Submission with regard to Amended Plans -Development Application DA2025/0115 Alterations and Additions to a Dwelling House 77 Bungan Head Road, Newport, NSW

I write regarding the above Development Application DA2025/0115 (DA) to make a submission to Amended Plans on behalf of Michael and Sharyn Goodwin (my clients), with regard to their property at 75 Bungan Head Road, Newport.

Figure 2 – Additional image taken from principle living area of 75 Bungan Head Road, using the existing chimney as a visual guide to demonstrate how the proposed development will result in view loss of the Bilgola Headland.

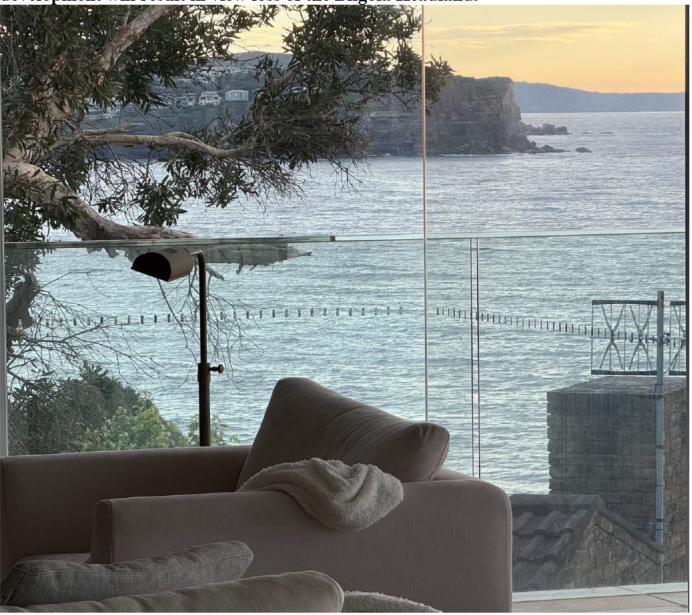
The site photos at figures 2 and 3 of this submission and the photos included in the 28 February submission, clearly demonstrate a severe loss of iconic views. An iconic view includes entire beach views and loss of headland views. As per the established planning principle, views from a kitchen and principle living area are highly valued because people spend so much time in these areas.

However, the VIA submitted does not include any view aspects from the principle living area, including the kitchen at 75 Bungan Head Road, and doesn't even make reference to view corridors from these highly valued areas. A VIA that does not include an assessment or report on the view loss from the principle living area should be discounted. As already discussed in this letter, the viewpoints selected for the VIA are limited to only two view aspects inappropriately located on the eastern part and lesser used section of the balcony, rather than the area adjacent to the principal living space.

Further to this, the VIA has assessed the entire view loss of Bilgola Beach as moderate. This assessment is strongly rebutted. It is entirely unreasonable to propose and accept an entire view loss of the Bilgola Beach view as moderate. This assessment is contrary to the Urbaine Group Assessment Table at Figure 8 of the draft VIA which notes that a moderate visual impact is, 'one where there is a medium negative impact on the pre-existing visual quality of the view'. Clearly, an entire view loss of Bilgola Beach cannot be considered as a medium negative impact.

The VIA submitted should be superseded (it is noted that it remains in draft form), and a revised VIA prepared to reference off certified height poles and include view assessments from the kitchen, principle living area and additional areas of the principal balcony adjacent to the living area. The VIA should also demonstrate how an entire view loss of Bilgola Beach is deemed moderate and assess the view loss of the Bilgola Headland.
